## Planning Application Response

<b>Local Authority:</b>	Barnsley
<b>Detail:</b>	MU1 –Hybrid application for residential development of 1,760 dwellings, construction of link road, Phase 1 residential development of 229 dwellings, outline permission for 1,531, primary school, shops and community facilities
<b>Planning Ref:</b>	2021/1090 - Residential
<b>Deadline:</b>	20 <sup>th</sup> October 2021
<b>Submitted by</b>	Trans Pennine Trail Officer
<b>Response to:</b>	<a href="mailto:DevelopmentControl@barnsley.gov.uk">DevelopmentControl@barnsley.gov.uk</a>
<b>Submitted:</b>	15 <sup>th</sup> October 2021
<b>Summary</b>	<p>The Trans Pennine Trail national office welcomes the opportunity to respond to this planning application.</p> <p>Whilst the TPT is not directly impacted by the site it is imperative to recognise the essential links needed to the Trail to enhance the sustainable transport offer of the site.</p> <p>There are many areas within the documentation provided where it isn't clear what footways / multiuser refer to – this was noted in our original consultation response. To enable consultees and developers to have a clear understanding of what will be delivered in terms of sustai

<b>Detailed Information:</b>	The plan below details the site in relation to the Trans Pennine Trail. The Yellow line is the TPT:

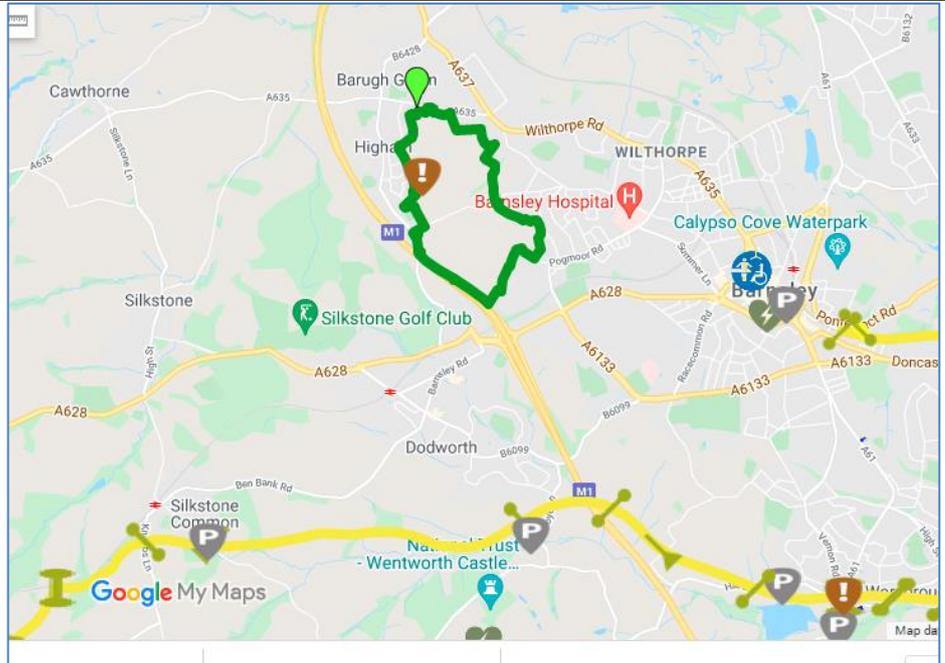
At this point the Trans Pennine Trail is also part of the National Cycle Network (NCN 62) and the long-distance walking route E8. The Trail is also full multi-use (walkers, cyclists and horse riders).
